Staff Report to the Plan Commission

Crossroads of Orland Park Mixed-Use Planned Development

Prepared: 2/14/24

Project: 2021-0286 – Crossroads of Orland Park - Planned Development

LOT 1 – RESTAURANT “C” WITH DRIVE-THROUGH

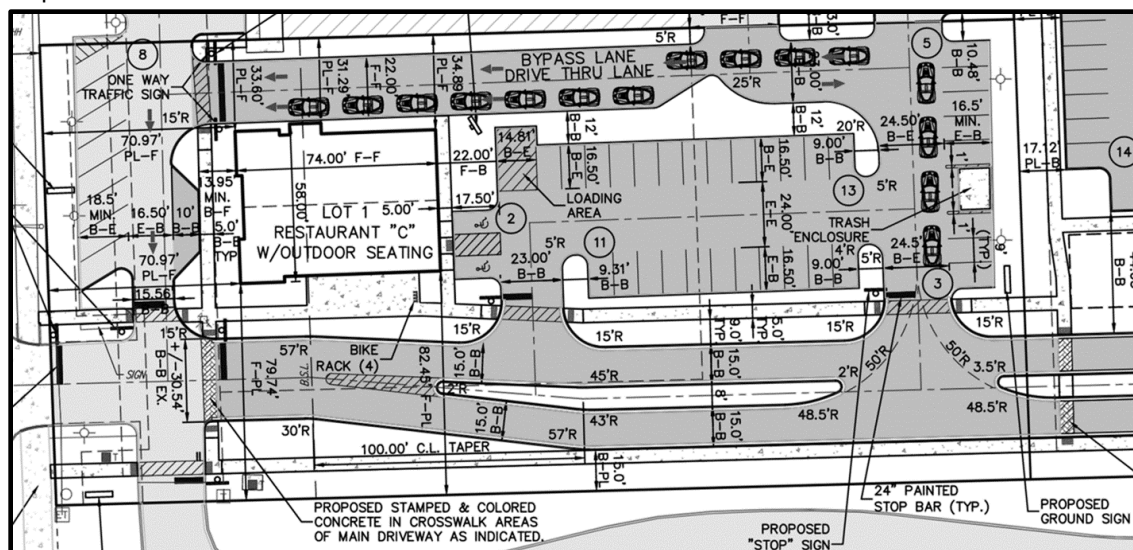
The restaurant “C” site has provided 2 additional parking spaces over the code-required number of spaces. Additionally, 4 bicycle parking spaces will be provided on the south side of the building.

Approximately 7 vehicles can queue from the pick-up window to the end of the drive-through lane and 8 vehicles can stack along the east/west drive aisle within the lot before reaching an internal site access road. It is important to note that these additional drive-through queues will not block vehicles from exiting the drive-through lane or the lot. If necessary, vehicles could queue within the site during peak times before reaching the internal roadway, reducing the traffic impact to Lot 1 itself. The approval for restaurant “C” is conditioned to abide by the maximum stacking space counts for Lot 1, otherwise a special use permit amendment will be required.

The trash enclosure is located on the east side of the main parking lot in the rear of the building. Signs are proposed in the front and rear of the building and will be reviewed through the sign permit process. There are no building elevations proposed for Lot 1 at this time. When a restaurant user applies to develop restaurant “C,” the proposed building footprint must be no greater than the 4,000 square foot building footprint illustrated on the site plan or else a special use amendment must be granted. If the development complies with the approved site plan and landscape plan, staff recommends that restaurant “C” would proceed through the appearance review process.

1. The development will be in substantial conformance with the site plan prepared by DesignTek Engineering, revised December 19, 2023 and the landscape plan, prepared by Westwood Environmental, revised December 17, 2023.
2. The proposed building footprint is no greater than the 4,000 square foot building footprint as illustrated on the site plan or else a Special Use Amendment must be granted.
3. If the development complies with the approved site plan and landscape plan, the development may proceed through the appearance review process.

Staff Recommends the Plan Commission approve a Special Use Permit for a Drive-Through Service Window for Lot 1 with the condition that any future restaurant tenant must have estimated drive-through stacking space needs equal to or lower than stacking counts outlined in the Traffic Impact Study Addendum prepared by KLOA dated September 22, 2023, or else a Special Use Amendment must be granted.

LOT 2 – RESTAURANT “B”

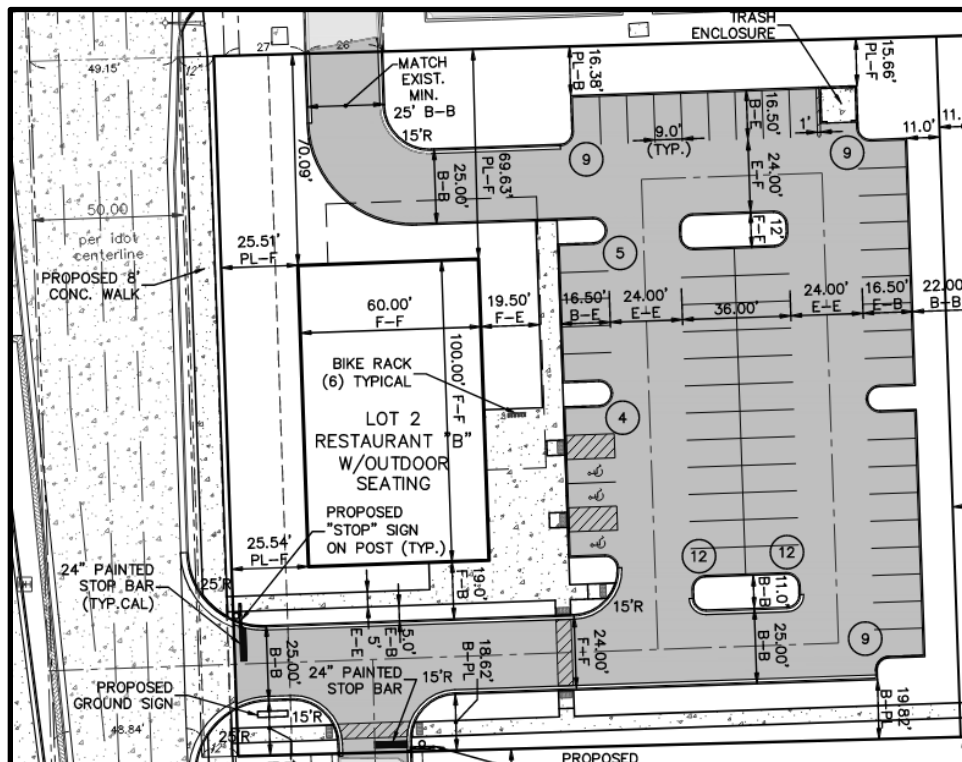
Trash handling areas must be screened from view from public streets and any abutting properties by opaque walls. The trash enclosure is located on the east side of the main parking lot. The trash enclosure includes 6' masonry walls that will be required to match the main building, per Section 6-302.D. Signage landscaping will be approved during the sign review process.

There are no building elevations proposed for Lot 2 at this time. When a restaurant user applies to develop restaurant “B,” the proposed building footprint will have to be no greater than the 6,000 square foot building footprint illustrated on the site plan or else a Special Use Amendment must be granted. If the development complies with the approved site plan and landscape plan, staff recommends that restaurant “B” would proceed through the appearance review process.

1. The development will be in substantial conformance with the site plan prepared by DesignTek Engineering, revised December 19, 2023, and the landscape plan, prepared by Westwood Environmental, revised December 17, 2023.
2. The proposed building footprint is no greater than the 6,000 square foot building footprint as illustrated on the site plan or else a Special Use Amendment must be granted.
3. If the development complies with the approved site plan and landscape plan, the development may proceed through the appearance review process.

LOT 3 – RESTAURANT "A" WITH DRIVE-THROUGH

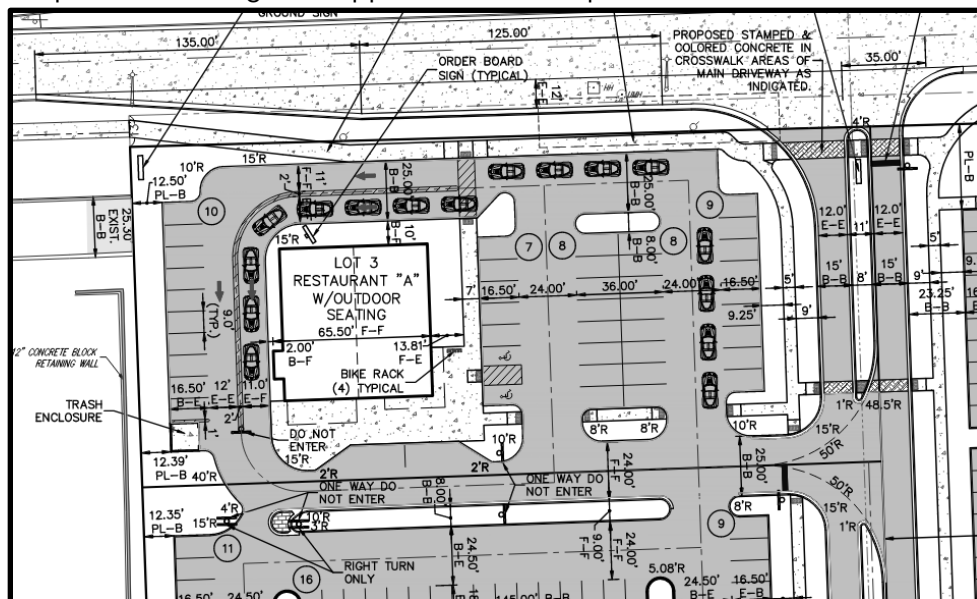
The parking requirement for Restaurant "A" is up to 40 vehicle spaces, while the proposed on-site parking is 38 vehicle spaces. Additional parking is available on lot 5, north of the luxury apartments. The Development Services Department reserves the right to require a connection between Restaurant "A" and the Pep Boys/NAPA site.

Vehicles access Lot 3 from the main roadway within the site and can reach the drive-through on the north side. A bypass lane and extra parking are provided along the north end of the drive-through. Due to staff concerns about vehicle circulation and cross-traffic close to 159th and LaGrange intersection, Lot 3 will not connect to the existing Pep Boys/NAPA stub street. About 8 vehicles can queue from the pick-up window to the end of the drive-through lane, more than the LDC requires. Additionally, 8 additional vehicles can queue along the drive aisles within the lot. These extra drive-through stacking spaces will not obstruct vehicles from exiting the drive-through lane or the lot. There is potential for additional vehicles to queue within the site before reaching the adjacent roadways during peak business hours. The trash enclosure is located on the west side of the drive through. The trash enclosure includes 6' masonry walls that will be required to match the main building, per Section 6-302.D. Signage landscaping will be approved during the sign review process. No building elevations are currently proposed for Lot 3. When a restaurant user applies to develop restaurant "A," the building footprint must not exceed the 4,000 square feet illustrated on the site plan. Otherwise, a special use amendment is required. If the development aligns with the approved site plan and landscape plan, staff recommends that restaurant "A" proceeds through the appearance review process.

1. The development will be in substantial conformance with the site plan prepared by DesignTek Engineering, revised December 19, 2023 and the landscape Plan, prepared by Westwood Environmental, revised December 17, 2023.
2. The proposed building footprint is no greater than the 4,000 square foot building footprint as illustrated on the site plan or else a Special Use Amendment must be granted.
3. If the development complies with the approved site plan and landscape plan, the development may proceed through the appearance review process.

Staff Recommends that the Plan Commission approve a Special Use Permit for a Drive-Through Service Window for Lot 3 with the condition that any future restaurant tenant must have estimated drive-through stacking space needs equal to or lower than stacking counts outlined in the Traffic

Staff recommends that the Plan Commission approve a Modification to allow for reduced drive-through landscape screening on the north side of the principal building (Section 6-305.D.2.c).

West Elevation

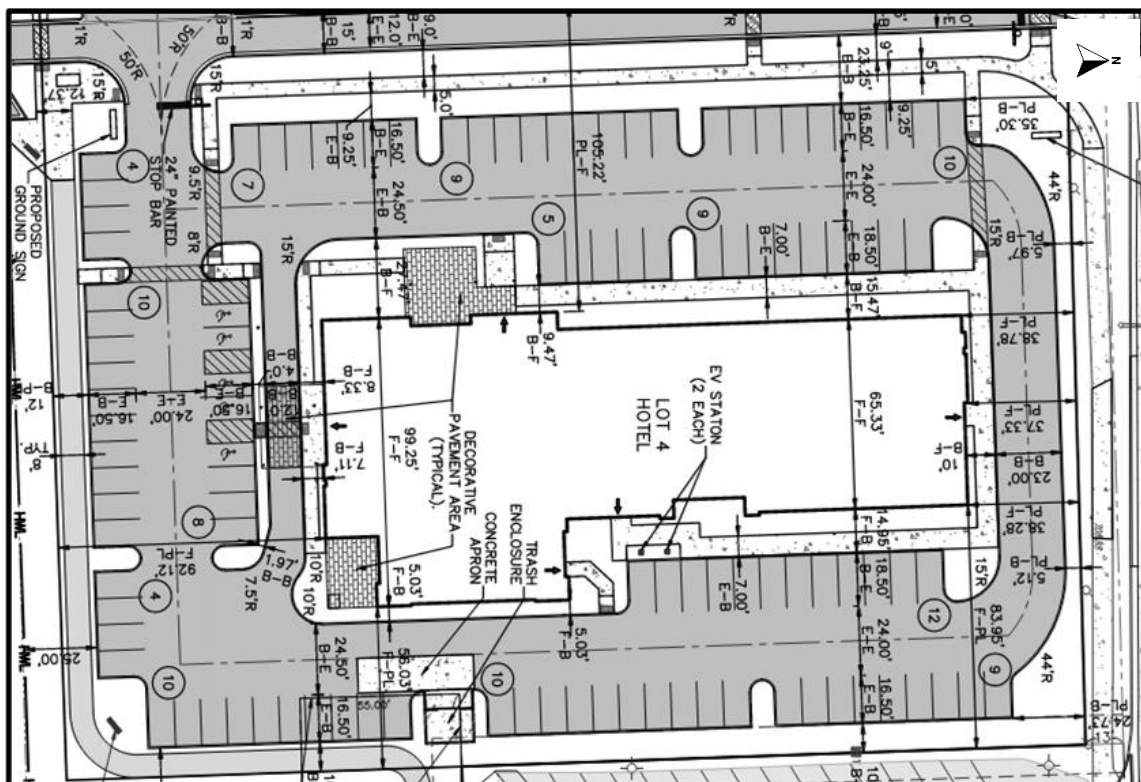
The west facing façade is very similar to the east but has a larger EIFS portion on the southwest corner of the building's upper floors. The first floor has the same stone material as the east side but has a large canopy over the outdoor patio on the site. The upper floors of the hotel are constructed primarily of brick in the color granite red and contain large windows throughout. Each floor is separated on the elevations with a brick soldier course pattern.

Staff recommends approval of the site plan, landscape plan, building elevations, and requested modification for the hotel parcel, due to its overall adherence to the LDC. Specifically, the modification for the driveway access aisle between the building and the street has been addressed through incremental improvements that exceed the minimum code requirements for design standards and site amenities. Overnight accommodations are a permitted use in the COR Mixed Use district, and the Regional Core land use designation outlined in the Comprehensive Plan supports vertical development, emphasizing the creation of an aesthetically pleasing public realm, overall aligning with the proposed plans for a hotel on lot 4.

Staff recommends that the Plan Commission approve the site plan, landscape plan, and building elevations for Lot 4, subject to the condition that the development will be in substantial conformance with the Site Plan prepared by DesignTek Engineering, revised December 19, 2023; the Landscape Plan, prepared by Westwood Environmental, revised December 17, 2023; and Building Elevations for Lot 4 prepared by Tech Metra, dated December 20, 2023.

Side Elevation (with garage)

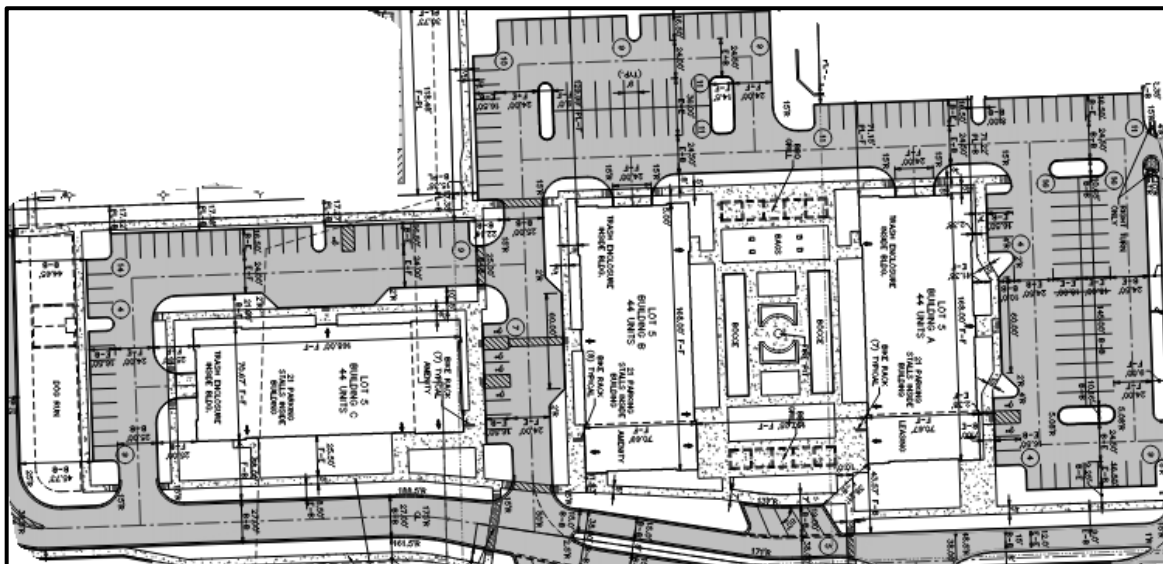
The side elevation with the garage is symmetrical with two balconies on each floor. The garage is centered on the first floor with windows on the corners. The 1st and 2nd floors are constructed entirely of red brick along with the corners of the 3rd and 4th floors. The 3rd to 5th floor recessed area on the center of the site is constructed of EIFS, along with the entire 5th floor.

Overall, the design of the luxury apartment buildings is consistent with the character of the surrounding land and design standards required in the COR zoning district. Material samples are available to the Plan Commission for review.

Staff recommends the Plan Commission approve a Special Use Permit for attached dwellings (Section 6-210.C.2) with the condition that the development will be in substantial conformance with the Site Plan prepared by DesignTek Engineering, revised December 19, 2023; the Landscape Plan, prepared by Westwood Environmental, revised December 17, 2023; and Building Elevations for Lot 5 prepared by Tech Metra, dated December 20, 2023.

LOT 6 – STORM WATER AND OPEN SPACE

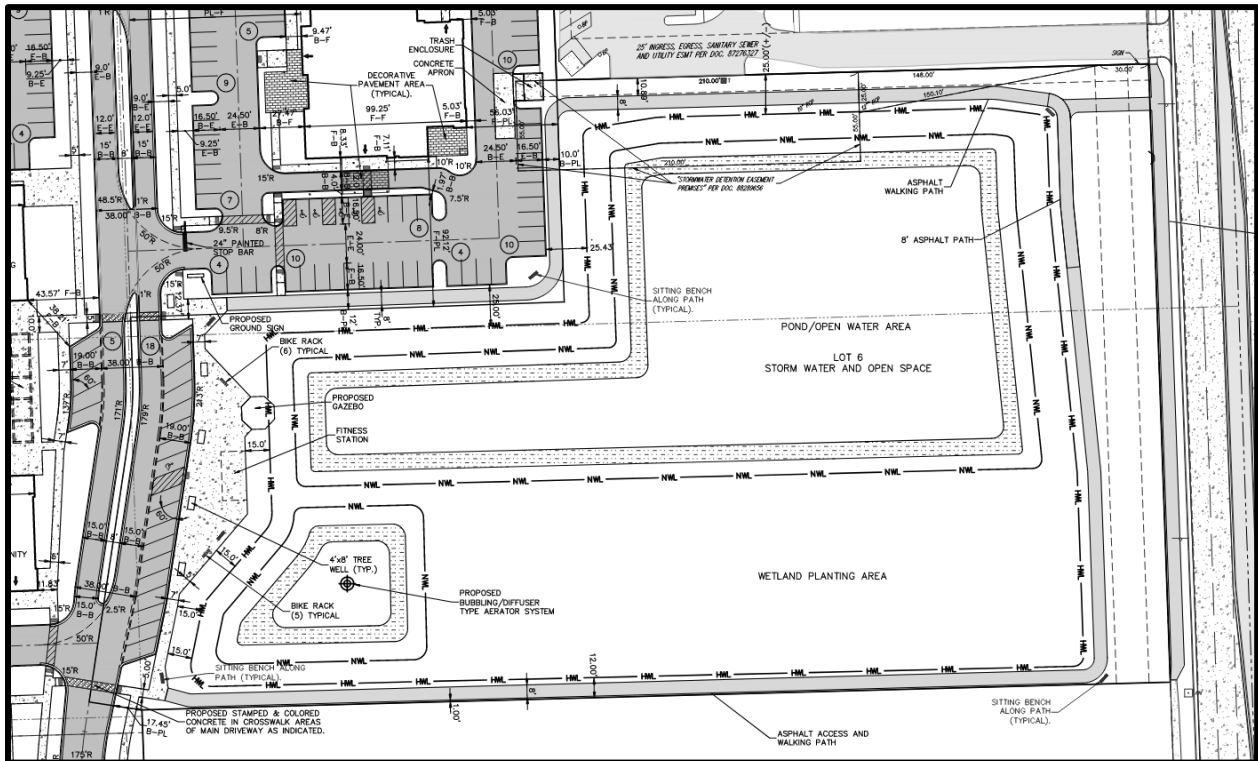
Lot 6 serves as the common open space and stormwater management area for Crossroads of Orland Park. There are 2 ponds and a wetland planting area proposed for this lot. Additionally, the open space area is equipped with a pathway encircling the entire site, complemented by benches, fitness equipment, and a gazebo that offers a scenic view of the fountain in the proposed pond. A special use permit has been requested to allow for the disturbance of a nontidal wetland, as detailed in the overall site plan section of this report. Additionally, modifications to the 25-foot setback and slope requirements for the pond have been proposed, specifically for the overlook area and the northern border of the pond along the hotel parcel border. Diagonal parking has been provided on lot 6 to accommodate use of this open space area and any additional residential guest parking demand.

Staff Recommends the Plan Commission approve a Special Use Permit for Disturbance of a nontidal wetland.
